Environmental Statement
Appendix H2
Outline Design Briefing Note for
Natural England. March 2022
Langstone FCERM SCHEME

Langstone FCERM Scheme - Review and refinement of outline design options

Figure 2: Frontage 3 (A3023 to The Look Out) refined concept options layout

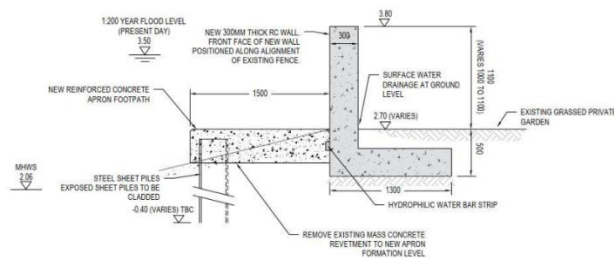
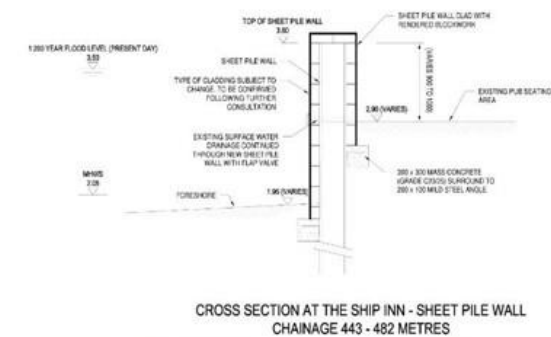
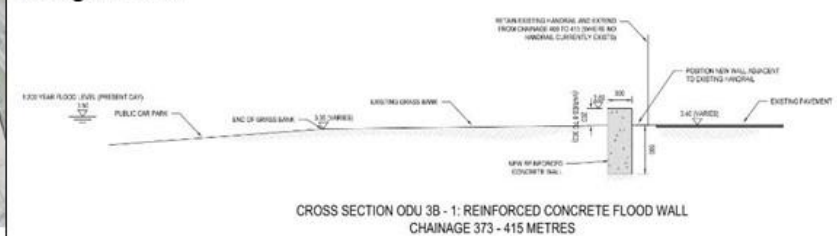
Frontage 3 is part of the Core scheme and runs between the east side of the A3023 and The Look Out (9 Coastguard Cottages) residential property and includes the Ship Inn Car Park. The changes between the outline design and updated refined concept option design for this frontage are shown in **Table 1**. The layout and cross-sections of the refined concept design option are shown in **Figure 2** and **Figure 3** below.

No intertidal encroachment into the European Marine Sites	No intertidal encroachment into the European Marine Sites. The new sheet pile wall along the Ship Inn beer garden boundary will be built on the existing alignment so there will be no permanent intertidal habitat loss. The sheetpile alignment along the apron will remain within the existing footprint so there will be no permanent intertidal habitat loss. Temporary loss/disturbance of intertidal habitat during construction
--	--

Ship Inn Car Park: Raised Car Park Flood Defence Level 3.6mAOD

Ship Inn: Sheet Pile Wall with Rendered Blockwork Flood Defence Level 3.8 mAOD Length 40m

A3023: Reinforced Concrete Flood Wall Flood Defence Level 3.6mAOD Length 55m

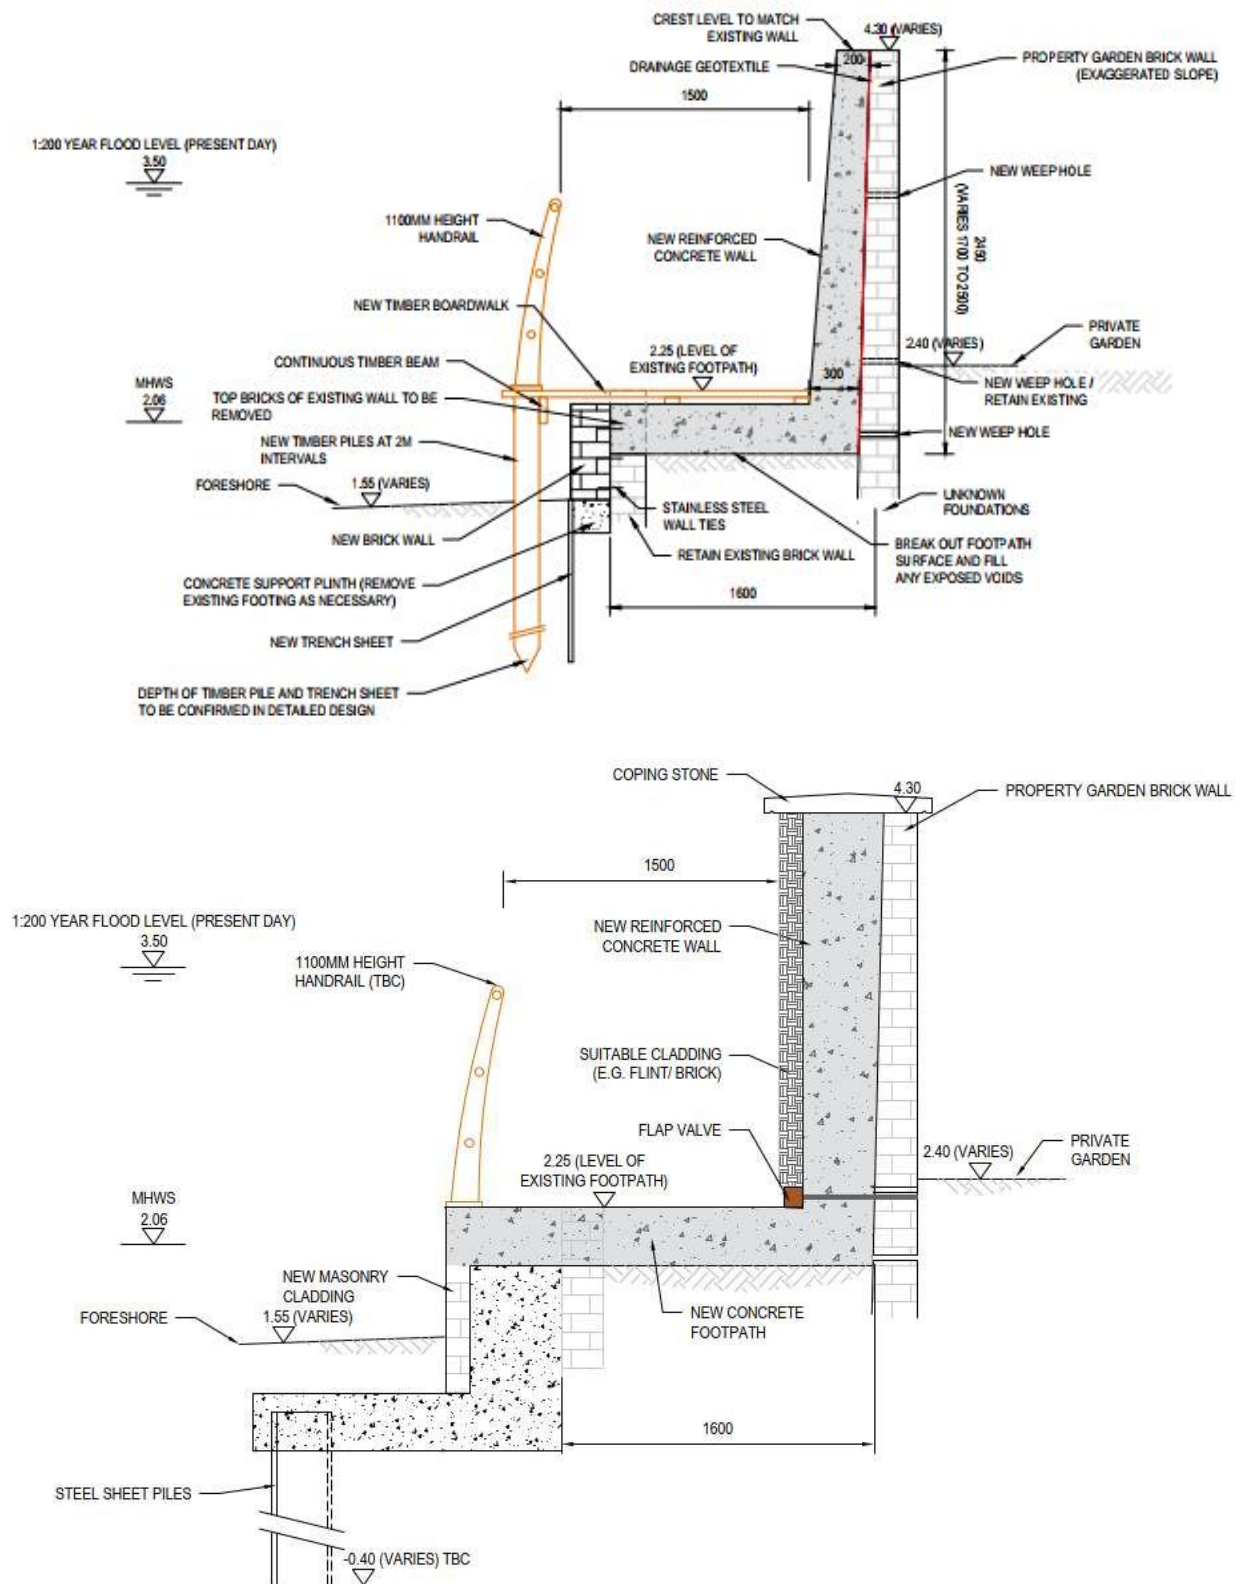
The outline design for this section of Frontage 4 was to construct a reinforced concrete floodwall and boardwalk seaward of the existing brick wall, with trench sheeting and a new brick quay wall constructed directly seaward of the existing quay wall, as shown in **Figure 4** below.

However, as described above for the whole of Frontage 4, the boardwalk option was ruled out due to operation and maintenance concerns and significant community opposition. Alternative options considered were:

However, following the results of the Structural Investigation, seepage analysis and receipt of ECI advice, both of these options have since been ruled out because they do not provide a continuous impermeable barrier, and therefore seepage would be expected to occur, and hence they do not meet the design requirements of the scheme to prevent future erosion risk as well as flood risk. Furthermore, the Structural Investigation found that the brickwork wall at The Look Out would require structural support to withstand the expected hydrostatic and hydrodynamic loadings with a sufficient factor of safety and the existing quay wall is in poor condition with multiple voids and a residual life of less than 10 years. Therefore, the existing brickwork wall and quay wall are unsuitable for reuse and incorporation into the scheme and new structures are necessary to provide the required design life and standard of protection to meet the scheme objectives.

In addition, the reinforced concrete L-shaped floodwall landward of the existing brick wall option doesn't enable Havant Borough Council (HBC) to meet their requirements to maintain an accessible footpath along the frontage. This option wouldn't see any work undertaken to the quay or footpath and the residual life of the quay footpath is less than 50 years.

Therefore, the updated leading option for The Look Out to Green Cottage is now the same as that proposed between Green Cottage and the Winklemarket - a reinforced concrete floodwall immediately seaward of the existing brickwork wall and masonry wall, clad in appropriate material. A new brick quay wall will be constructed seawards of the existing sea wall to provide the required footpath width of minimum 1.5m. The new quay wall will have sheet pile foundations with a buried concrete apron/slab to minimise permanent intertidal habitat loss as far as technically possible. It should be noted that along this section of the frontage, the footpath in many parts is already at 1.5m and in some areas wider so it may be that during detailed design it is possible to create some habitat gains in some section to offset the losses in other areas where the footpath is currently narrower. The foreshore encroachment will be kept to the absolute minimum necessary and intertidal habitat losses and gains will be fully described and quantified in the detailed design for inclusion in the Habitats Regulations Assessment to be submitted in support of the planning and marine licence applications.

The outline design, updated concept design option and alternatives considered for The Look Out to Green Cottage are summarised in **Table 2** below. A typical cross-section of the updated concept design option is shown in **Figure 4**.

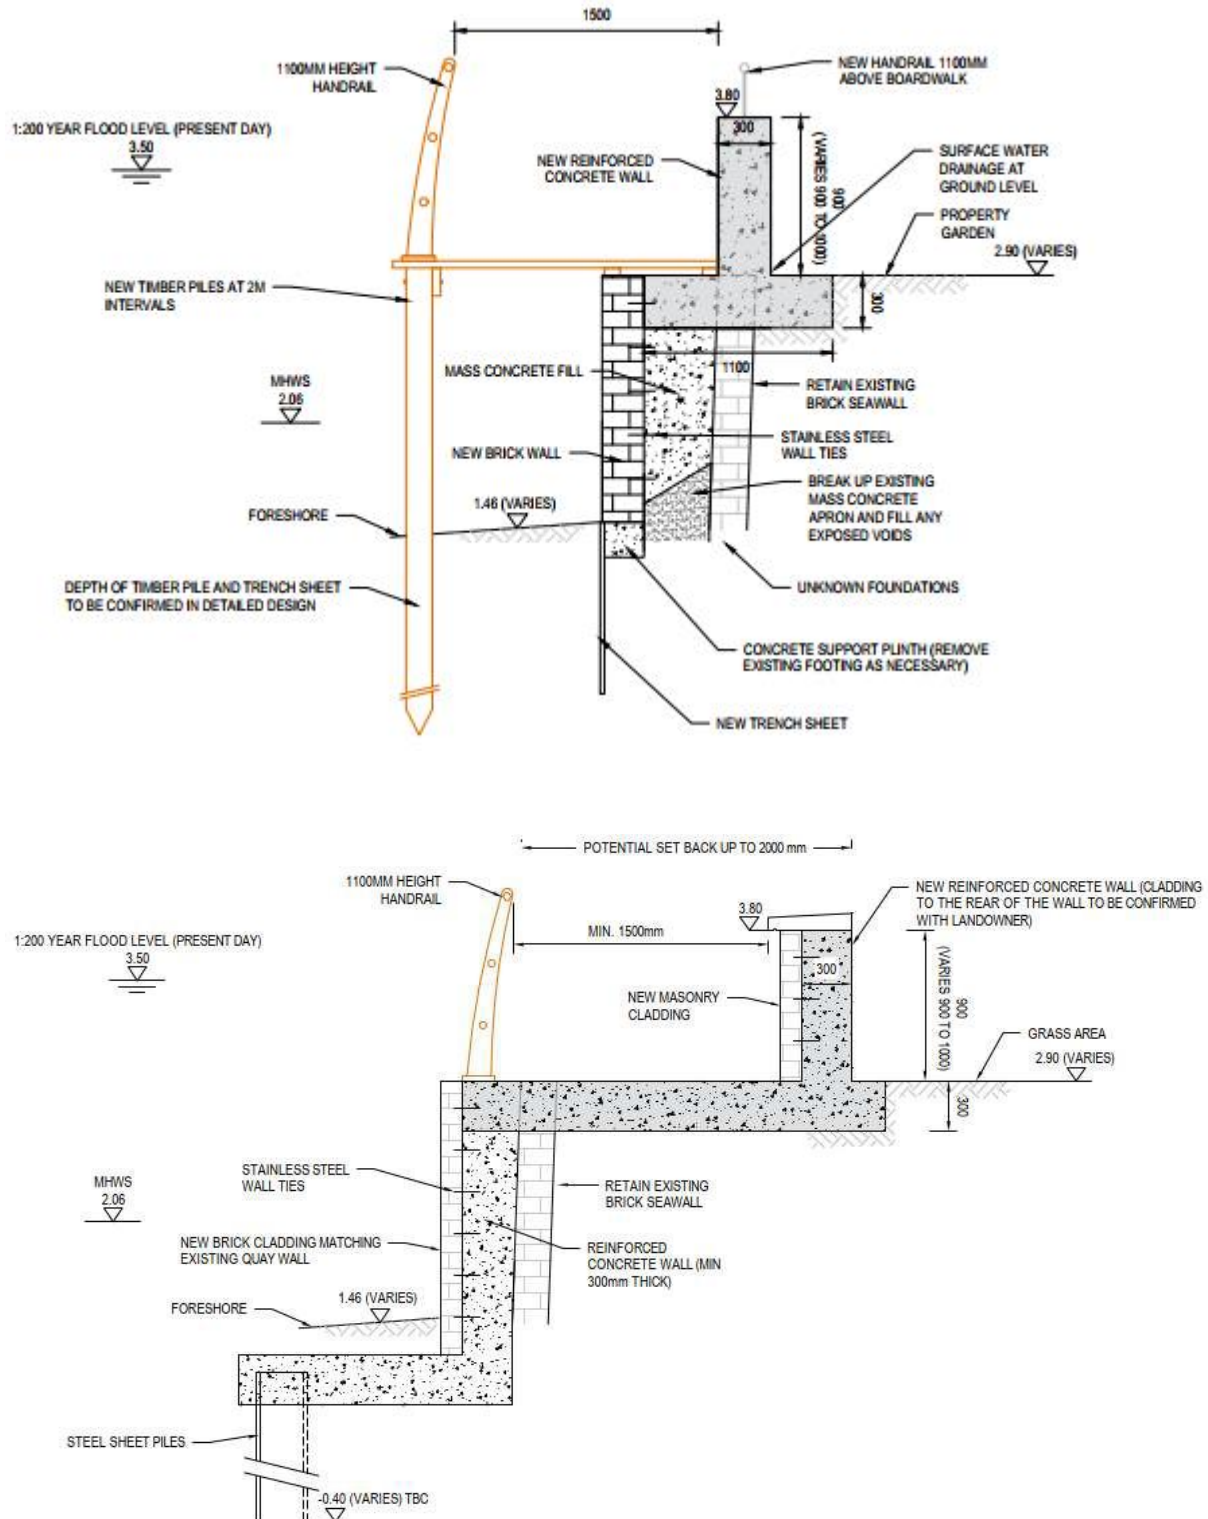
The outline design for this section of Frontage 4 was to construct a reinforced concrete T-shaped floodwall around the edge of the green area with a boardwalk to preserve the footpath width, as shown in **Figure 5** below. A new brick wall with mass concrete fill was also proposed to be constructed seaward of the existing quay wall and apron.

In addition to this outline design, an alternative design solution was also considered, assessing whether the new quay wall could be constructed with an 'overhang' to reduce the amount of foreshore encroachment by the new quay wall, following strong community feedback regarding the boardwalk. This solution was however ruled out as there would be issues associated with uplift forces caused by the wave action beneath the overhang section. Furthermore, due to the complexities associated with this solution, the cost of this approach was anticipated to be higher than the updated leading option, and there would also be issues with 'shading/shadowing' of the foreshore, even if direct encroachment would be minimised. Subsequent community feedback also opposed the cantilevered path approach.

The results of the structural investigations indicate that the existing brickwork wall around the green is in poor condition and is unsuitable for reuse and incorporation into the scheme. In addition, the tall masonry wall and the dwarf masonry wall are not compliant with current design standards. Seepage calculations also indicate that under existing conditions there is a risk of uplift and seepage through the frontage during periods of high-water levels, as the quay wall and footpath fill are permeable, and therefore an impermeable cut-off is required to prevent this. These results combined, therefore mean that it is not possible to make use of the existing walls as the flood defence without any modifications as the design requirements of the scheme would not be met.

In addition, the owners of Green Cottage have stated that the scheme cannot take any land on the northern extent of the green due to the fragility of the Grade II listed building (the end gable wall is only of single skin construction) and they do not want flood waters being brought closer to the property. Therefore, the northern extent of the green cannot be taken landward of its existing alignment and all the width of the footpath must be provided seawards of the existing alignment at this location. Along the eastern edge of the green, the landowners have agreed to a 1:1 land exchange with the area of existing footpath. This approach is to ensure the owners of Green Cottage comply with their legal obligations to preserve the listed status of the building and its curtilage.

Considering the structural investigation results, information above and receipt of ECI advice, the updated leading option for the green is to construct a reinforced concrete T-shaped floodwall around the edge of the green area, with no boardwalk or overhang path, as shown in **Figure 5** below. The footpath is to be constructed seaward of the T-shaped floodwall, with a new brick quay wall constructed seaward of the existing quay wall to provide adequate footpath width. Foundations of the new brick quay wall will be a concrete apron with sheet piles, buried beneath the foreshore to minimise permanent intertidal habitat loss as far as technically possible. There will be a limited amount of permanent encroachment into the intertidal habitat as the new quay wall will be seaward

of the existing quay wall, but the majority of the new footprint will be within the footprint of the existing concrete apron.

The outline design, updated concept design option and alternatives considered for Green Cottage are summarised in **Table 3** below. A typical cross-section of the updated concept design option is shown in **Figure 5** below.

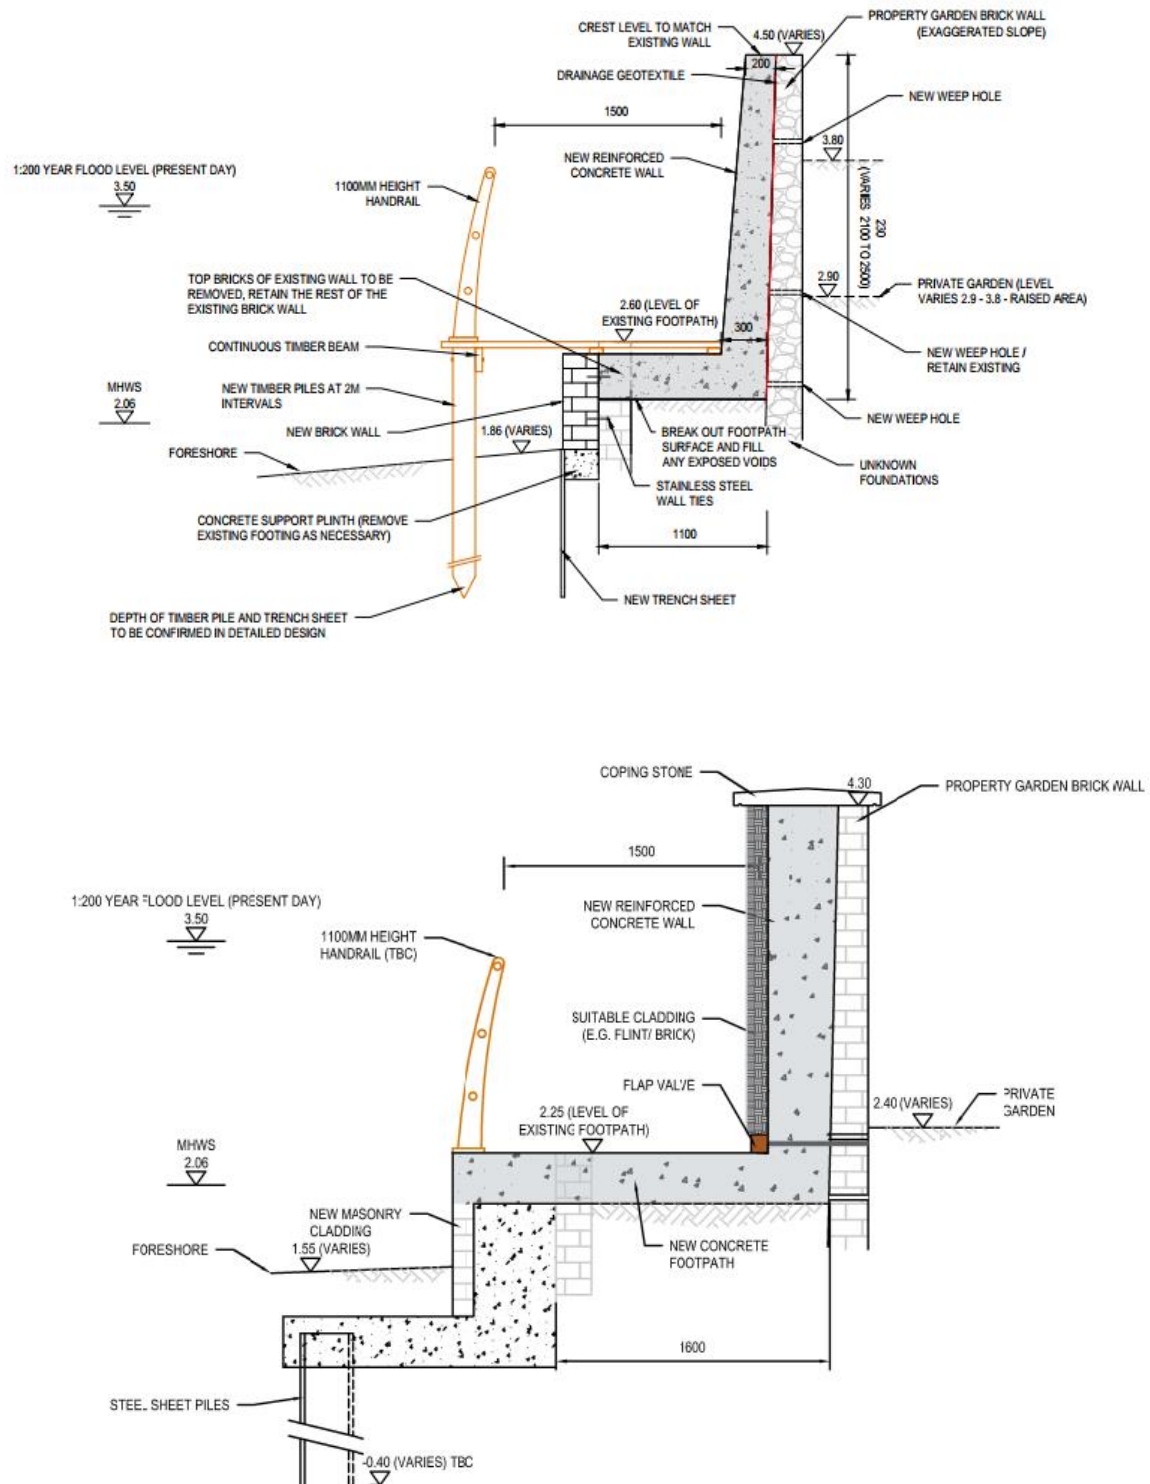
The outline design for this section of Frontage 4 was to construct a reinforced concrete floodwall and boardwalk, with the floodwall constructed immediately seaward of the existing brick wall, and trench sheeting and a new brick quay wall constructed directly seaward of the existing quay wall, as shown in **Figure 6** below.

However, as described above for the whole of Frontage 4, the boardwalk option was ruled out due to operation and maintenance concerns and significant community opposition. Alternative options considered were:

However, following the results of the Structural Investigation, seepage analysis and receipt of ECI advice, all three of these alternatives were ruled out.

The overhang solution was ruled out as there would be issues associated with uplift forces caused by the wave action beneath the overhang section. Furthermore, due to the complexities associated with this solution, the cost of this approach was anticipated to be higher than the updated leading option, and there would also be issues with 'shading/shadowing' of the foreshore, even if direct encroachment would be minimised. Subsequent community feedback also opposed the cantilevered path approach.

The results of the structural investigation indicated that the existing walls are not suitable for reuse or incorporation into the design without any modifications. Furthermore, seepage analysis identified a risk of seepage along the frontage indicating requirement for an impermeable cut-off. The existing quay wall is in poor condition and in need of replacement with a new quay wall in order to provide sufficient structural support to the new floodwall on top of the footpath, adjacent to the existing flint wall.

Therefore, the updated concept design between Green Cottage and the Winklemarket is now the same as that proposed for The Look Out to Green Cottage - a reinforced concrete floodwall immediately seaward of the existing flint wall, clad in appropriate material. A new brick quay wall will be constructed seaward of the existing quay wall, to provide the required footpath width of minimum 1.5m, as shown in **Figure 6** below. The new quay wall will have sheet pile foundations with a buried concrete apron/slab to minimise permanent intertidal habitat loss as far as technically possible. The foreshore encroachment will be kept to the absolute minimum necessary and the majority of the new quay wall footprint is expected to be within the footprint of the existing concrete apron. The intertidal habitat losses and gains will be fully described and quantified in the detailed design for inclusion in the Habitats Regulations Assessment to be submitted in support of the planning and marine licence applications.

The updated concept design option for the Green Cottage to Winklemarket section of Frontage 4 is shown in **Table 4** below. A typical cross-section of the updated concept design option is shown in **Figure 6**.
